SEMINOLE COUNTY GOVERNMENT
 1101 EAST FIRST STREET, 2ND FLOOR, WEST WING
 SANFORD, FLORIDA 32771

PROJECT NAME:	DIXON RD - PRE-APPLICATION	PROJ #: 24-8000026
APPLICATION FOR:	DR - PRE-APPLICATION DRC	
APPLICATION DATE:	2/27/24	
RELATED NAMES:	EP BRENDA PEARCE	
PROJECT MANAGER:	KATHY HAMMEL (407) 665-7389	
PARCEL ID NO.:	26-20-29-300-0010-0000	
PROJECT DESCRIPTION	PROPOSED SPECIAL EXCEPTION FOR A NEW WATER METER SYSTEM ON 10.98 ACRES IN THE A-1 ZONING DISTRICT LOCATED ON THE SOUTH SIDE OF DIXON RD, EAST OF SUNSHINE TREE BLVD	
NO OF ACRES	10.98	
BCC DISTRICT	5: Herr	
CURRENT ZONING	A-1	
LOCATION	ON THE SOUTH SIDE OF DIXON RD, EAST OF SUNSHINE TREE BLVD	
FUTURE LAND USE-	SE	
APPLICANT:	CONSULTANT:	
BRENDA PEARCE BLACK & VEATCH/SUNSHINE WATER 200 WEATHERSFIELD AVE ALTAMONTE SPRINGS FL 32714 (678) 656-5179 PEARCEB@BV.COM	N/A

PROJECT AREA ZONING AND AERIAL MAPS

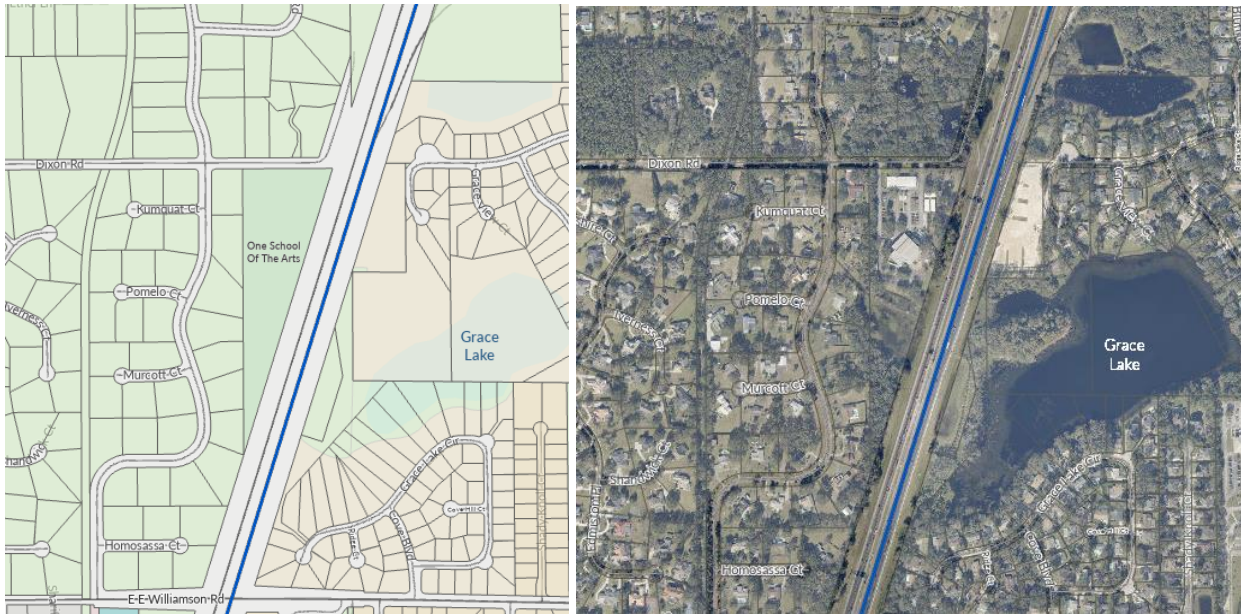
The parcel located within unincorporated Seminole County has a zoning classification of A-1 (Agriculture).

10.	Public Works - Engineering	<p>Based on the FEMA FIRM Map portion of the site is located in the floodplain. The entire south side of the parcel is in the wetland area; however, the proposed location of the antenna is outside of the wetlands and the floodplain.</p>	Info Only
